STAFF RECOMMENDATION
322 Harvard Avenue
June 15, 2016

Application: New construction - addition
District: Richland-West End Neighborhood Conservation Zoning Overlay
Council District: 24
Map and Parcel Number: 10405018400
Applicant: Ben Azzi, ZMX Inc.
Project Lead: Sean Alexander, sean.alexander@nashvill.gov

Description of Project: The applicant is proposing to construct a rear addition to the house.

SITE PLAN

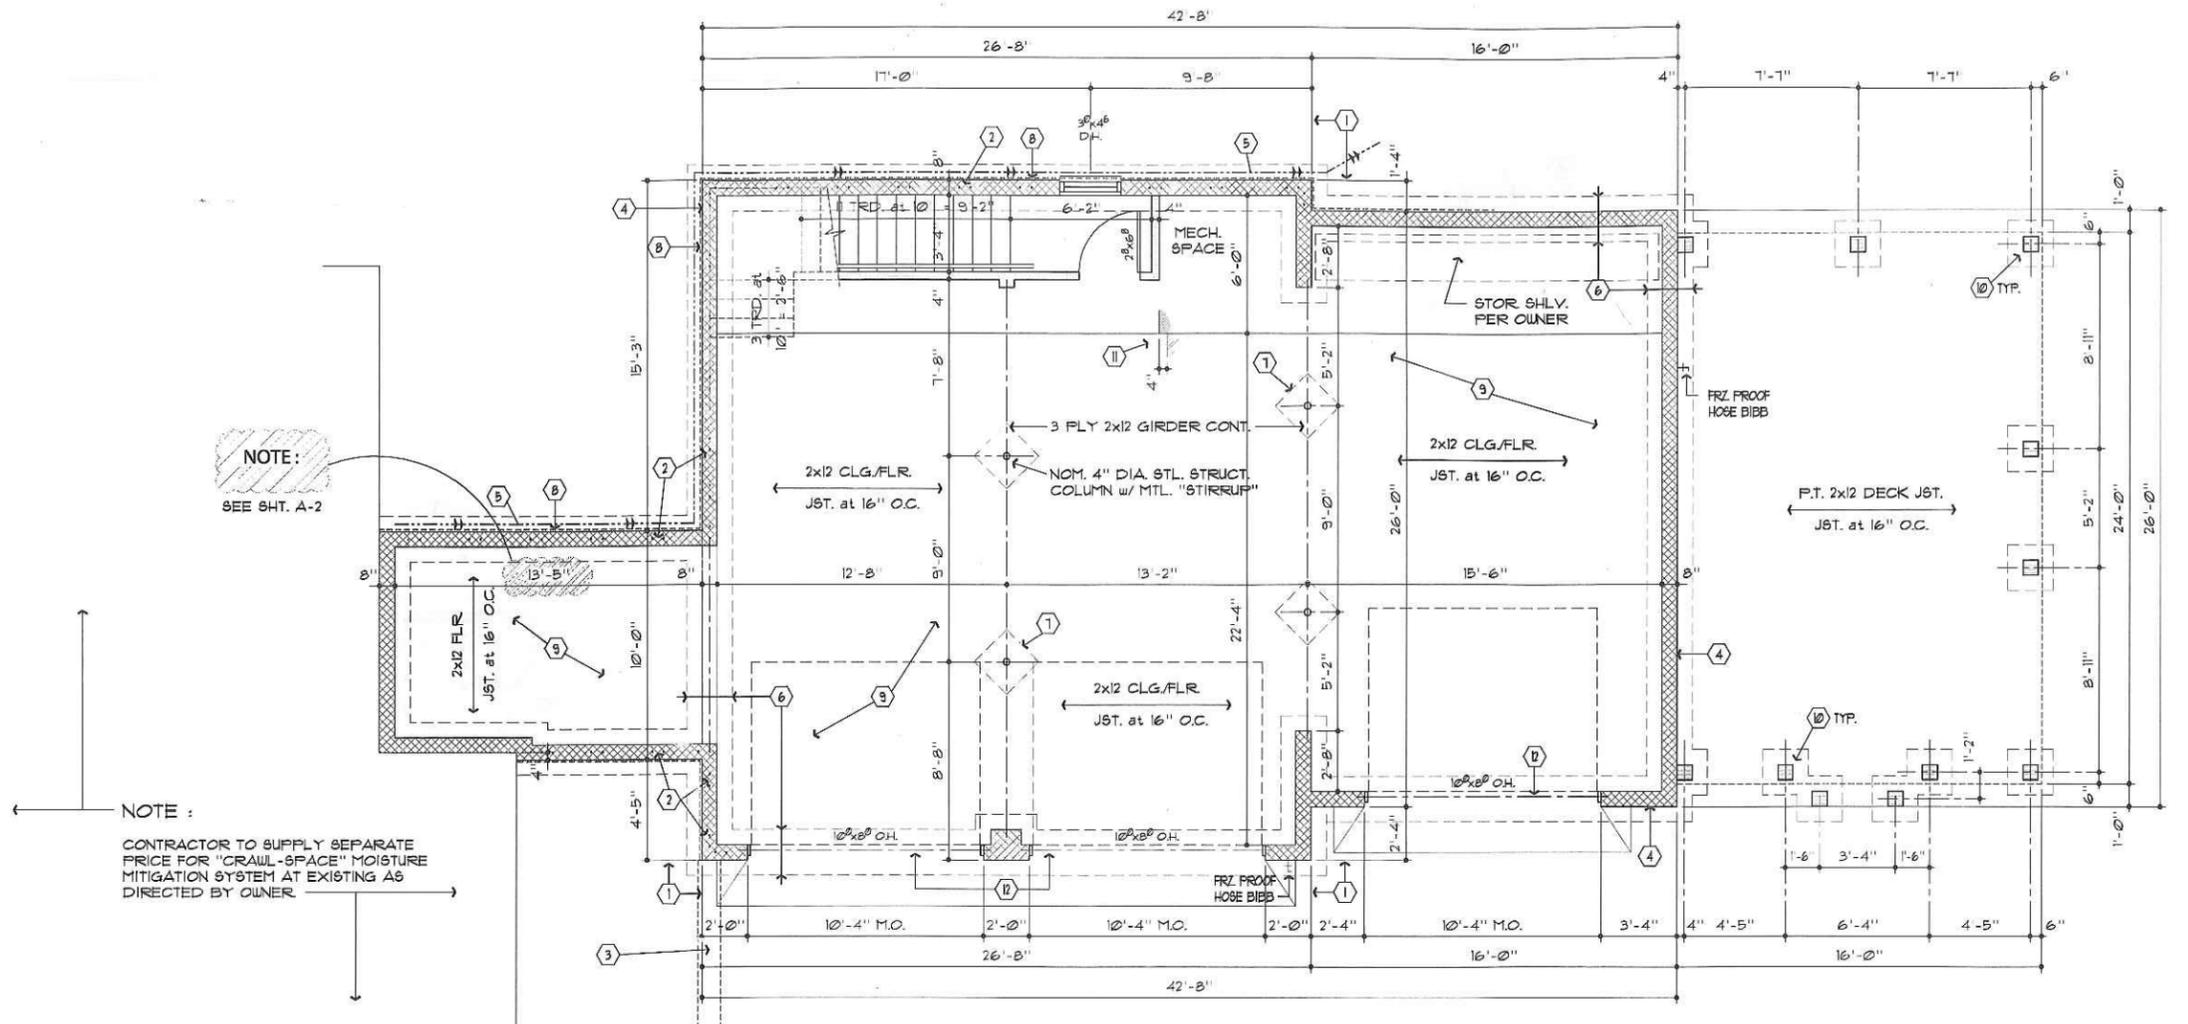
Appurtenances & Utilities: The existing right side gravel driveway will be paved with ribbon strips and extended to the rear, and an existing gate will be replaced. No other changes to the site's appurtenances were indicated on the drawings. The location of the HVAC and other utilities was also not noted. Staff recommends that they be relocated that the HVAC be located on the rear façade, or on a side façade beyond the midpoint of the house. The project meets section II.B.1.i.

EXTERIOR ELEVATIONS

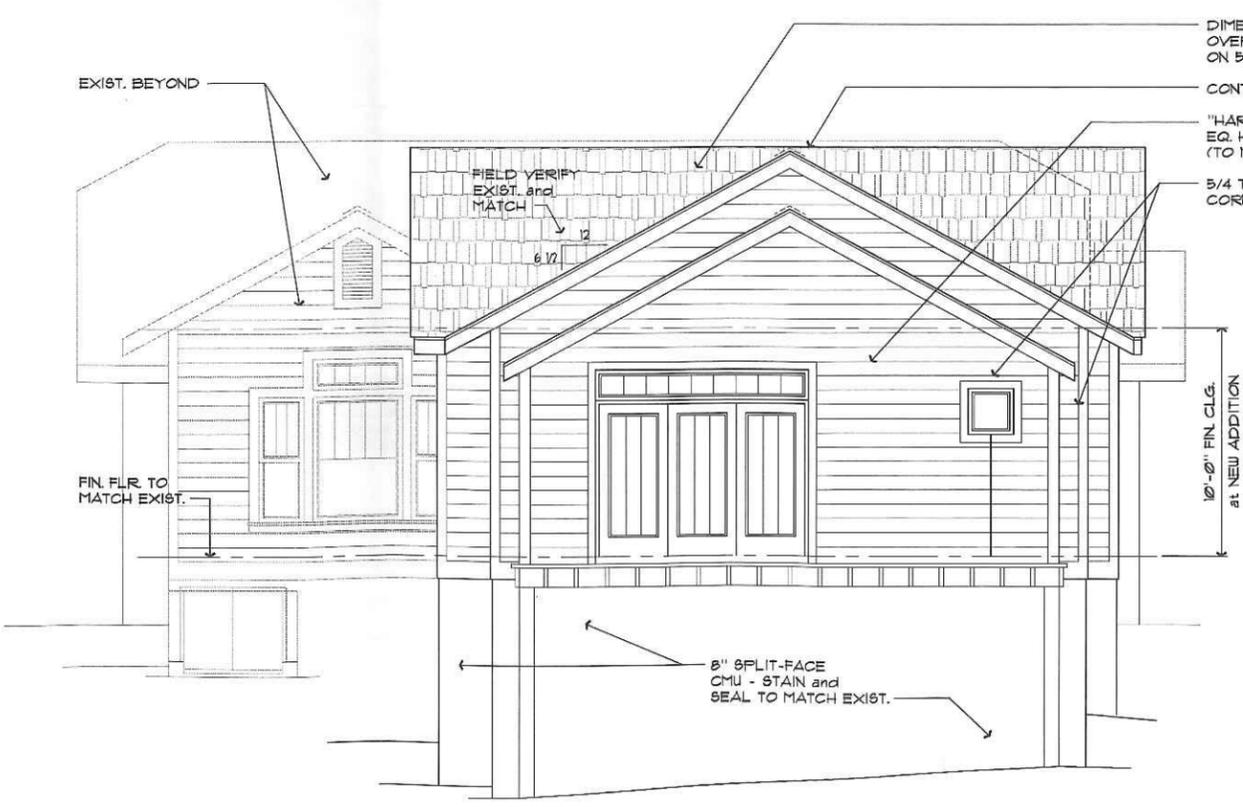
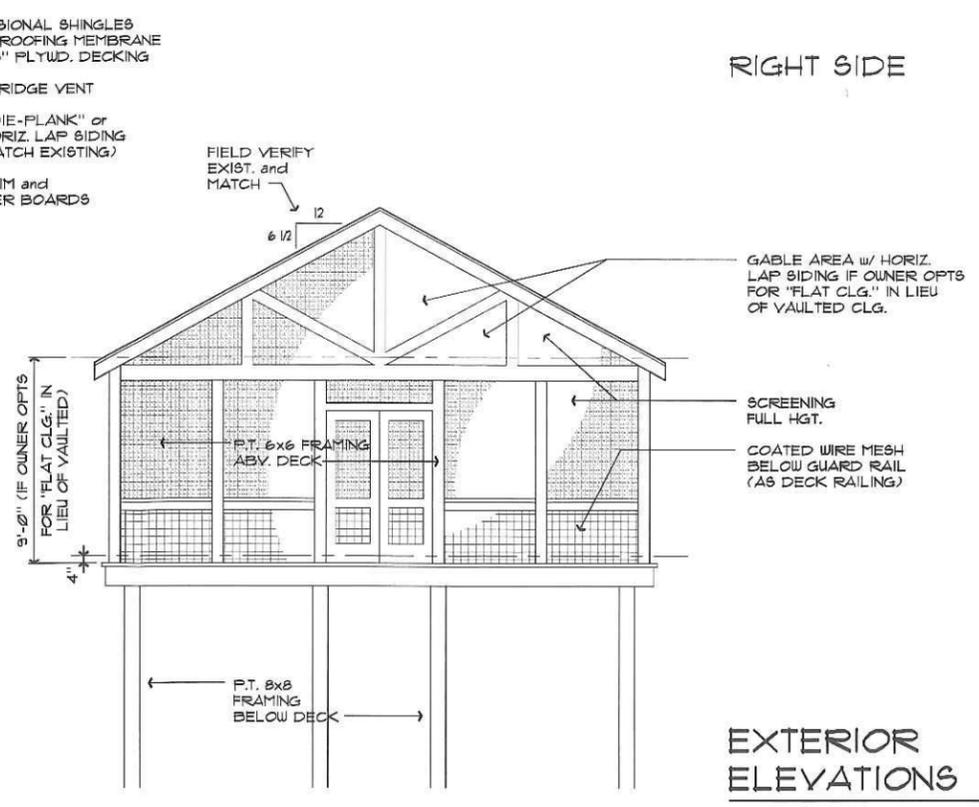
Roof form: The new roof will be a side-oriented gable with a pitch of 6:12. The original roof has a clipped gable with the same pitch. While the ends of the new gable roof are not clipped, Staff finds the similar roof forms to be generally compatible. The covered porch at the rear will have a gabled roof with a lateral chimney on the right side. Staff finds the roof forms to be compatible with those of surrounding historic houses and to meet section II.B.1.e of the design guidelines.

Proportion and Rhythm of Openings: No changes to the window and door openings on the existing house were indicated on the plans. The windows on the proposed addition are all generally twice as tall as they are wide, similar to the proportions of historic window openings. There are no large expanses of wall space without a window or door

- The windows and doors shall be approved by MHZC Staff prior to purchase and installation; and
- The exterior of the right side chimney shall be masonry or stucco. Masonry sample shall be approved by MHZC Staff prior to purchase and installation; and
- The HVAC shall be located at the rear or behind the midpoint of the structure.
